# Village of Estero Monument Sign Locations

David Willems, P.E.

# Monument Sign Locations

# US 41 North

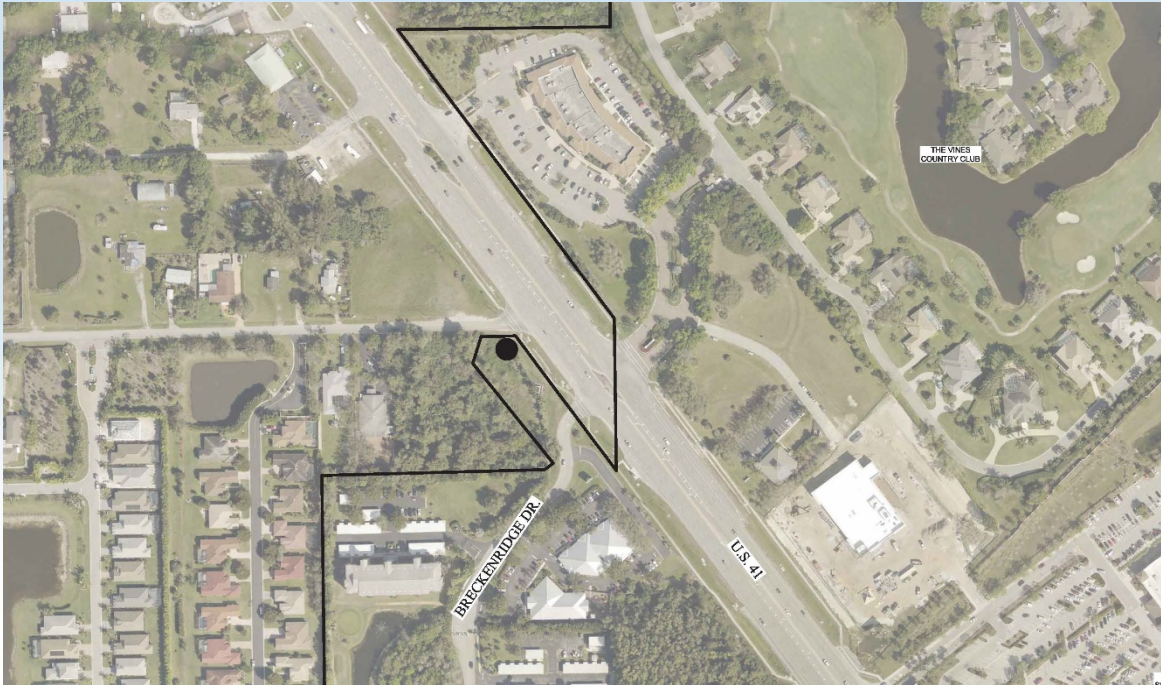
1. Utility conflicts
2. Swale modifications (culverts)
3. Locate outside right-of-way on Breckenridge Association property?
4. Coordinate w/ Breckenridge sign
5. Remove guard rails
6. Clear zone requirements

# US 41 South

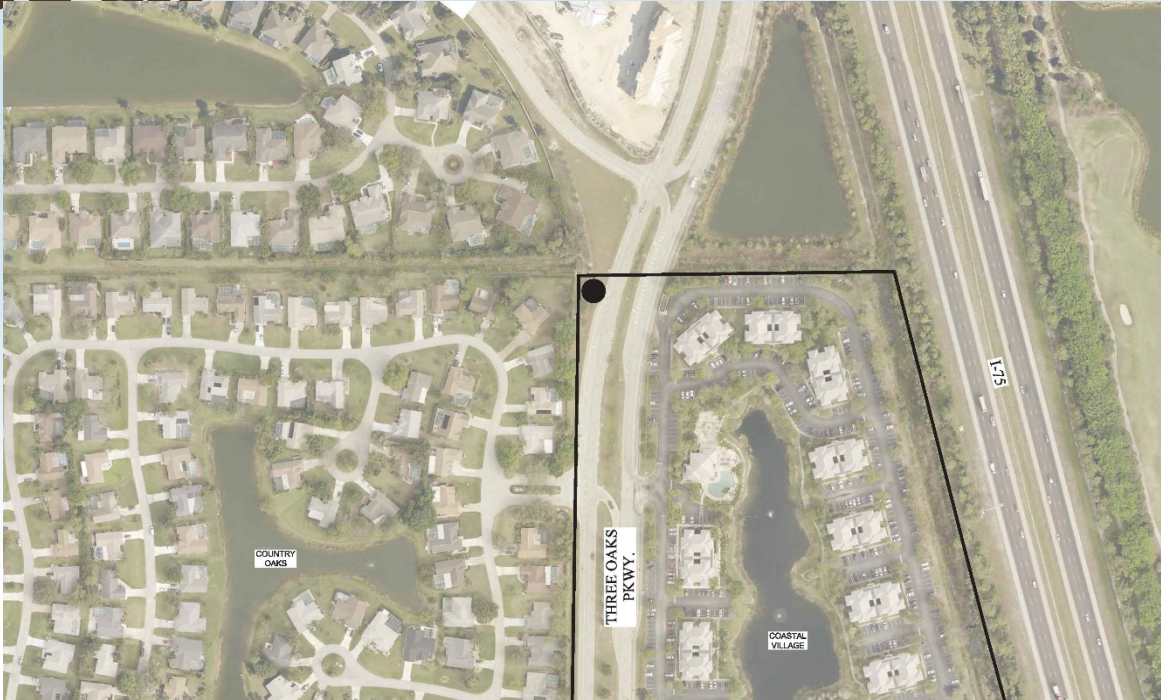
1. Utility conflicts
2. Coordinate w/ Coconut Point sign
3. Swale modifications (culverts)
4. Clear zone requirements

# Three Oaks Parkway North

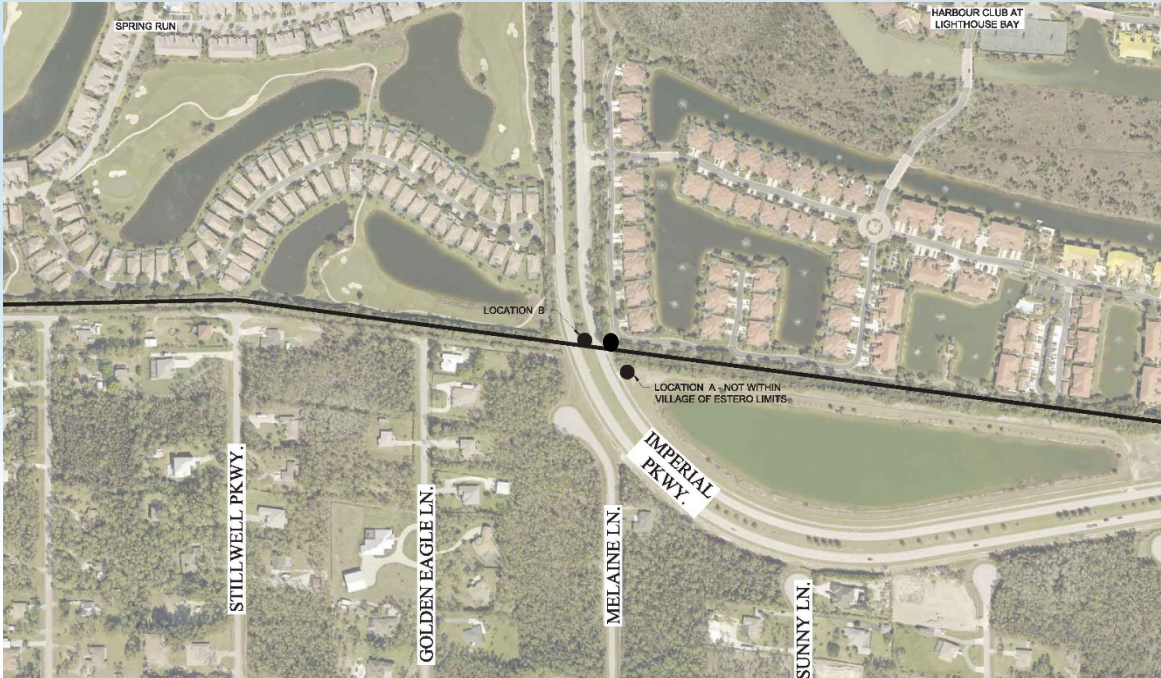
1. Is this the appropriate location? -  
West side of road is not in Estero
2. Utility conflicts
3. Relocated street light
